Case File Number: PLN17437

April 14, 2021

Location:	913-923 Martin Luther King Jr. Way (APN: 002 -0023-021-00/022-00/023-00). (See map on reverse)
Proposal:	Construction of a four-story, 23-unit residential building on a vacant interior parcel. The ground floor would consist of amenity space, an entrance to the parking garage, and two residential units. The upper stories would consist of a total of 21 residential units.
Applicant:	Y.H.L.A. Architects
Owner:	Paul Chung
Planning Permits Required:	Regular Design Review for the construction of a four-story multi-family residential building (O.P.C. 17.136.050A).
General Plan:	Central Business District
Zoning:	CBD-R Central Business District Residential Zone
Environmental Determination:	Pending
Historic Status:	Area of Primary Importance (API): Grove Street/Lafayette Square Residential
City Council District:	III
Action to be Taken:	Review development proposal and provide comments to staff for Zoning Manager decision

CITY OF OAKLAND PLANNING COMMISSION

1 EAST ELEVATION (MLK JR WAY)
SCALE: 1/8" = 1'-0"

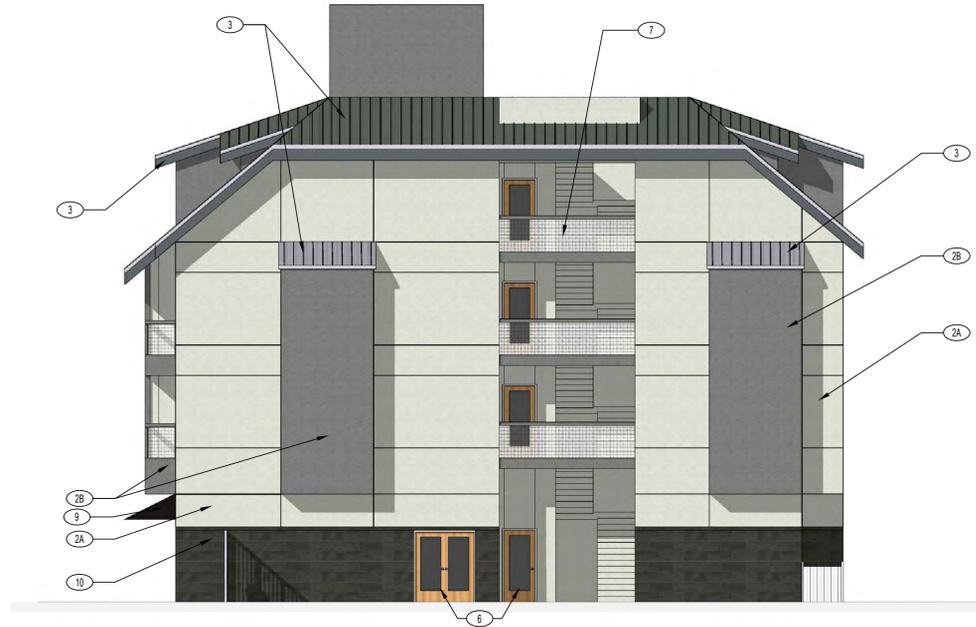
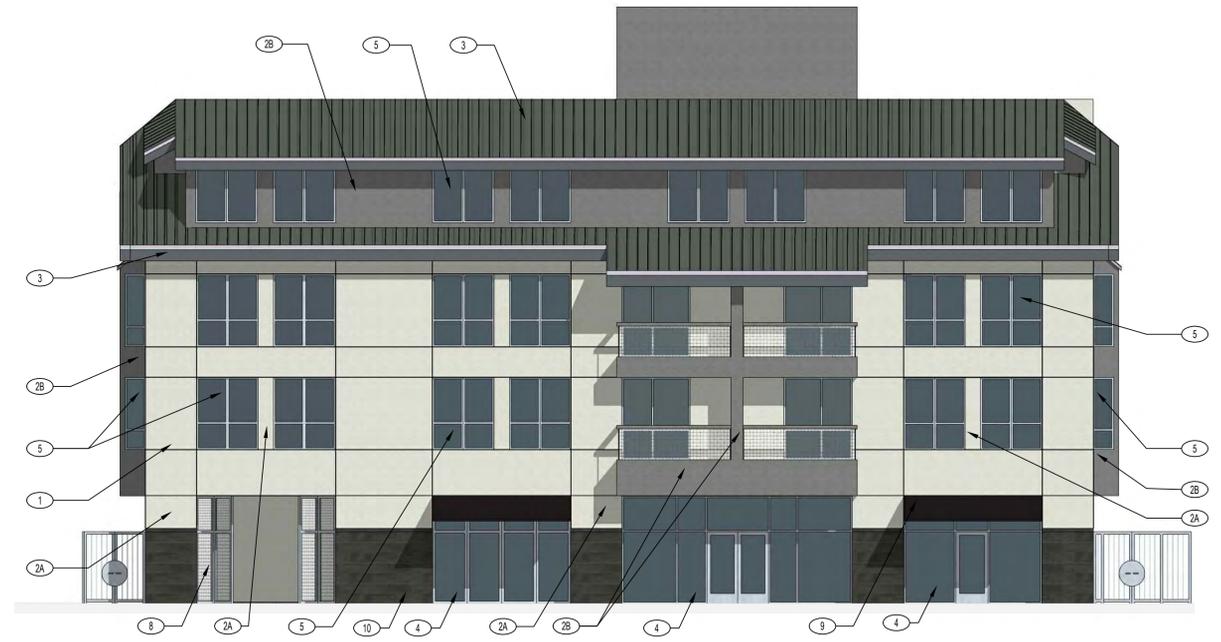
Staff believes that the current proposal does not adequately reference design elements in the Grove Street/Lafayette Square Residential district such as its massing, rhythm, materials, architectural detailing, scale, and volumes. Note that the design does not need to replicate other building styles in the neighborhood, but a design relationship should be established.

As mentioned above, the neighborhood generally contains smaller buildings on lots narrower than the project site with buildings setback from the side property lines. The proposal does not create volumes that reflect this rhythm of buildings along the block face. Solid articulations such as bays, instead of the proposed balconies, would establish a more contextual element to relate to the street rhythm.

The neighborhood is characterized by buildings with quality detailing such as pediments; window trim, recess, and decorative sash; decorative woodwork, and ornamental railing. The proposed building should replicate this level of detail quality throughout the building, and particularly on the ground floor.

2 NORTH ELEVATION
SCALE 1/8"=1'-0"

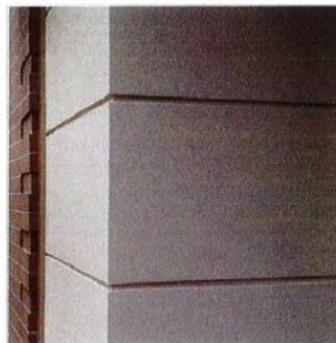
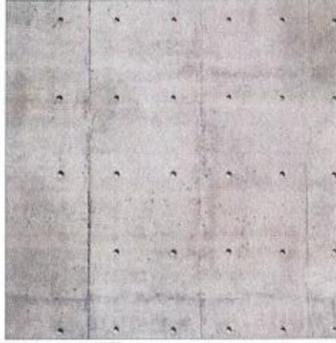
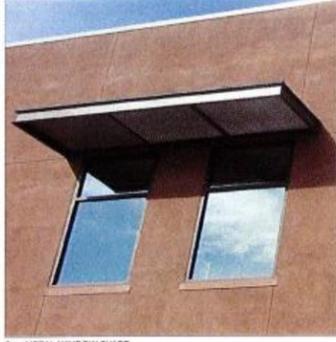
- Define different planes and masses that create pleasing proportions on the façade. The proposed bi-lateral curtain wall needs to be replaced with polygonal or rectangular bays.

- Masses can be defined through the use of siding, colors, balconies, decorative materials or other architectural elements for the different volumes and planes of the building.

- Integrate architectural details to provide visual interest to the façade of the building.
 - Provide high quality window detailing and treatments consistent with the design API such as decorative sash, single/double hung windows, and punctuated recesses.

- Provide pediments and ornamental railings consistent with the building design.
- Create a transition along the south side of the development where lower height and densities buildings and homes are located.

- Provide ground floor elevations showing all materials, details, colors, and recesses.
- Establish a prominent entrance for the building along the facade facing M L King Jr Way to create a prominent entrance:

- Orient the main residential entrance to the primary street.
 - Commercial entrances should be recessed to provide visual emphasis to the entrance and provide a break in the façade.

Staff recommends the applicant relate the new building to the existing architecture in the block face and integrate character defining elements of the API into the building design. Specifically, the API has a character defining height limit of 45 feet; the proposed building should create a singular wall plane height of 45 feet and any additional building height should be set back from the front facade. The volume of the building above the 45-foot height should be distinct, separating itself from the building base through the use of a water table line or decorative features in a way to not replicate the neighborhood design but instead provide elements that tie into the neighborhood context. Integrate building wall articulations to break long continuous building frontages into shorter widths that maintain desirable lower density contexts in the neighborhood. Furthermore, create a transition along the south of the development where lower height buildings and homes are located.

The is requesting a concession or waiver from the height standards as part of the affordable housing density bonus. Even with the bonus request, measures can be taken from a design standpoint to provide recesses and step backs to relate the building to the height context standards.

The composition of the building façade also needs to be revised. The bi-lateral split face composition of the building with the integrated cantilevered bay projections attempts to incorporate a design element not readily found in the district. The proposal also contains exterior materials that are not readily seen in the district. Staff recommends the applicant relate the new building to architectural elements seen on other buildings within in the block face such as window opening patterns, bay projections and exterior materials.
